MWO 9-1005-319-20-2

MODIFICATION WORK ORDER

**MODIFICATION OF
RIFLE, 5.56MM, M16A4
(NSN 1005-01-383-2872)**

30 Nov 2006

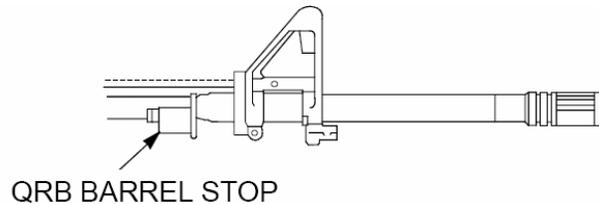
- (1) Loosen carrying handle nuts (1) but do not remove the nuts.
 - (2) After loosening nuts, clamp should be loose. Remove carrying handle (2).
- c. Removal of Handguards.

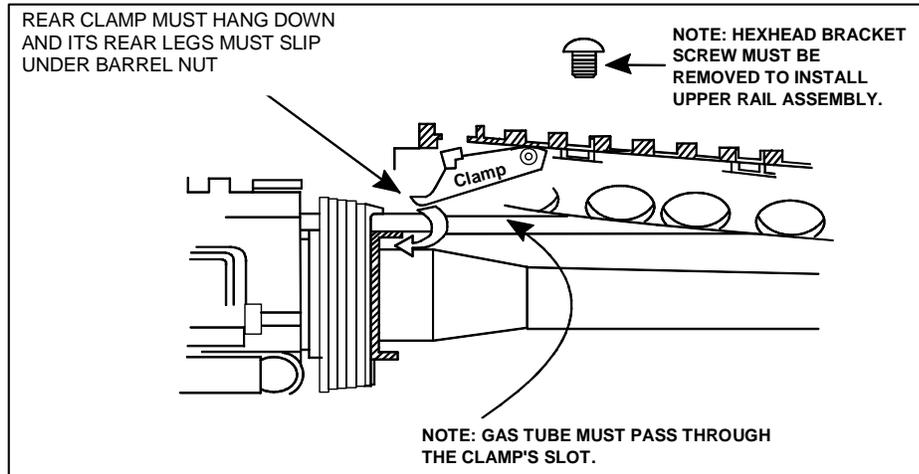
- (1) Install the stop by placing it over a thin section of the barrel from the six o'clock position, while avoiding contact with the gas tube.
- (2) Rotate it so its opening is pointed towards the gas tube.
- (3) Slide the stop forward until the flat vertical portion fits into the triangular sides of the forward handguard cap with the springs to the rear.

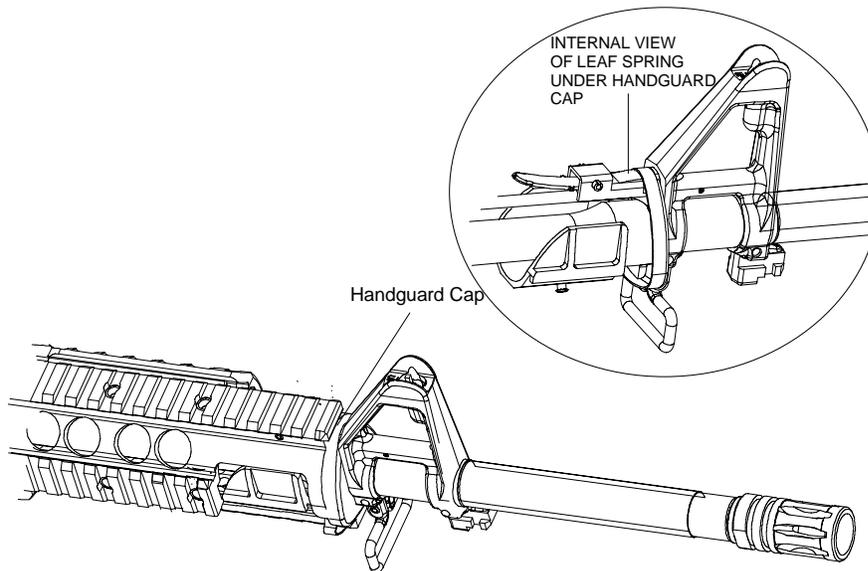
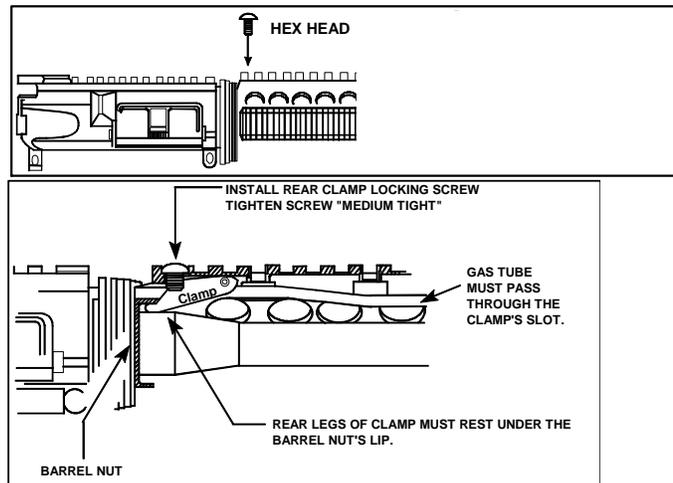
- (1) Orient the upper adapter rail so the rear locking clamp is hanging down after confirming that the arrow on its inner surface points towards the muzzle of the host weapon.

- (2) Insert the front end of the upper adapter rail into the forward handguard cap at an angle. Be sure the leaf spring at the front of the adapter rail fits inside the lip of the handguard cap.
- (3) Ensure the notches at the front edges of the rifle upper adapter rail engage the tabs at the rear edges of the barrel stop as the rifle is engaged and lowered into its final position.
- (4) Continue installing the upper adapter rail in the same manner as a standard upper handguard by compressing the handguard slip ring and pivoting the upper adapter rail down into its fully locked position around the barrel nut.

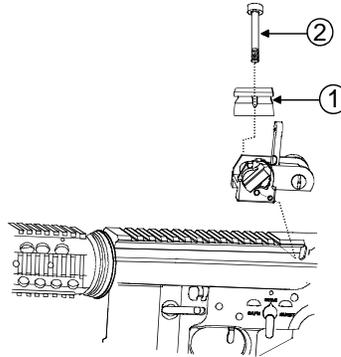
(1) Position rail cover so that the retaining clip is toward the muzzle.

(2) Depress retaining clip with thumb and slide on until the retaining clip locks into the end notch on the adapter rail.

(3) For the top rail cover, position retaining clip towards the rear, depress retaining clip, and slide on from the rear of the weapon until retaining clip locks into end notch.

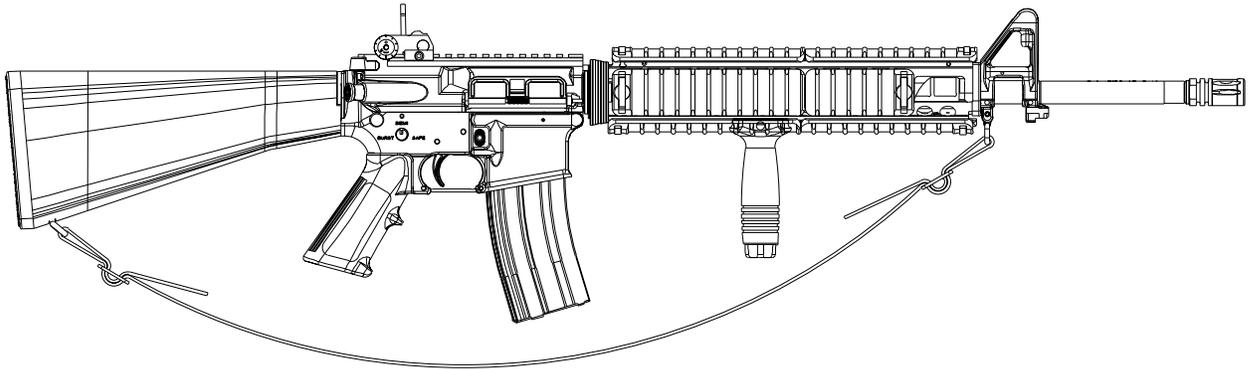
15. MODIFICATION IDENTIFICATION. Visual verification of application can be made as shown in illustration.
